ERRATA

Versal AI Edge - VE2302 Development Kit – Carrier Card - Revision 1

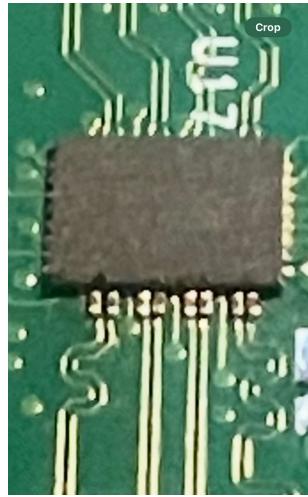
JTAG PC4 Connector Not Functional

Description – The JTAG PC4 connector was designed into the platform as a fall back to the USB Type-C JTAG/UART in case of issues with JTAG programming of initial prototypes. There is a select circuit which chooses the USB-Type-C connector or the JTAG PC4 connector dependent on if the Type-C is connected or not. When the USB Type-C connector is not plugged in (PC4 connector selected), the VE2302 Carrier Cards +UTIL_3V3 voltage is being back fed through the JTAG/UART device, U27, onto the +USB_5V0 line through protection device U30 at a level preventing the select circuit from functioning as intended.

Workaround – Utilize the USB Type-C connector, J53, for programming and debug requirements. In future board revisions, the PC4 connector, J35, will not be installed.
